ACCESSION NBR:8410160182 DOC.DATE: 84/10/09 NOTARIZED: NO DOCKET #
 FACIL:50-397 WPPSS Nuclear Project, Unit 2, Washington Public Powe 05000397
 AUTH.NAME AUTHOR AFFILIATION
 SORENSEN,G.C. Washington Public Power Supply System
 RECIP.NAME RECIPIENT AFFILIATION
 SCHWENCER,A, Licensing Branch 2

SUBJECT: Forwards addl info re safety parameter display sys,in
 response to NRC 840810 request re Suppl 1 to NUREG-0737.

October 9, 1984
G02-84-534

Subject: NUCLEAR PLANT NO. 2
NRC REQUEST FOR ADDITIONAL INFORMATION -
SAFETY PARAMETER DISPLAY SYSTEM (SPDS)

DIAGRAMATIC ISOLATOR CONNECTIONS

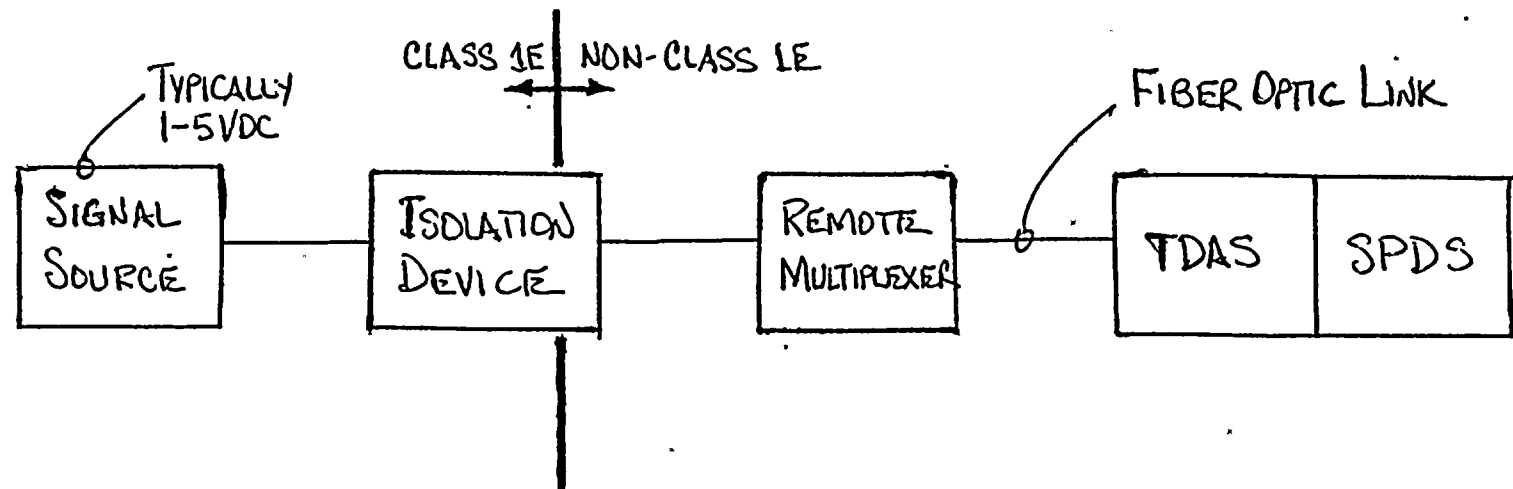
For each type of device used to accomplish electrical isolation, describe the specific testing performed to demonstrate that the device is acceptable for its application(s). This description should include elementary diagrams when necessary, to indicate the test configuration and how the maximum credible faults were applied to the devices.

The SPDS displays in the WNP-2 Main Control Room receive their signal inputs from the Transient Data Acquisition System (TDAS). TDAS consists of computer-based data collection and reduction equipment receiving input signals from both Class 1 and Non-Class 1 equipment. All inputs to TDAS interface through Class 1 isolation devices (one per signal input) hardwired to a multiplex unit. The multiplexer transmits signals to the computer, and ultimately to SPDS, through a fiber optic link. Therefore, the only Non-Class 1 equipment interfacing with the Class 1 isolation devices are the multiplexers. Refer to Attachment 1.

The isolation devices are provided to prevent failures in the Non-Class 1 TDAS multiplexers from affecting Class 1 equipment or other signal-sensitive equipment signal input sources.

The isolation devices utilized in the WNP-2 design are manufactured by Analog Devices, Inc. These devices (Model #289) are isolation transformer-type driven by operational amplifiers. They provide electrical and electronic interference protection with a 2500 vdc Common Mode Voltage (input to output) rating, as well as 120 db Common Mode Rejection between input and output common.

The TDAS multiplexers require a power source of ± 15 vdc. Therefore, the maximum credible fault potential which can be applied to the output of the device is ± 15 vdc. This is the same potential which powers the isolation device electronics. Thus, the maximum credible voltage which may be applied to these devices can have no effect on the inputs. Even though the maximum credible applied voltage is low, the isolation devices were tested with an applied voltage of 2500 v to the output terminals (signal to common), resulting in no effect (measured in millivolts of disturbance) on the input terminals. Additionally, the isolation devices were tested with a typical signal input (1-5 vdc) configuration to show that the input was unaffected by shorting the output terminals together or shorting either or both output terminals to ground.

Figure 2. Model 289 Block Diagram

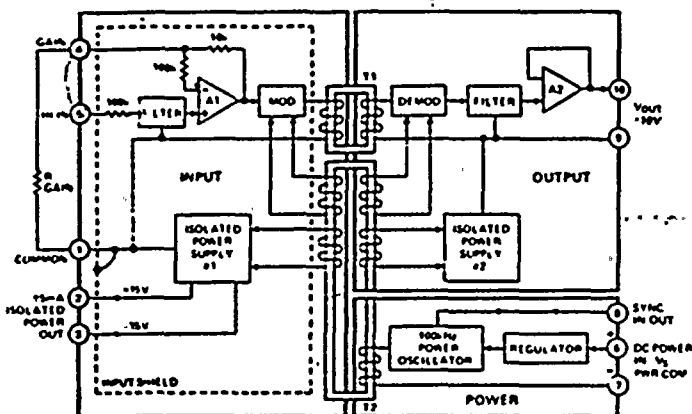
Data to verify that the maximum credible faults applied during the test were the maximum voltage/current to which the device should be exposed, and define how the maximum voltage/current was determined.

Attached is a block diagram of the isolation device (Attachment 3) and an electrical schematic of the TDAS multiplexer power supply (Attachment 2) they feed, showing ± 15 vdc as the maximum credible voltage which may be applied to the output terminals through the multiplexer. Refer also to Question a) Response above.
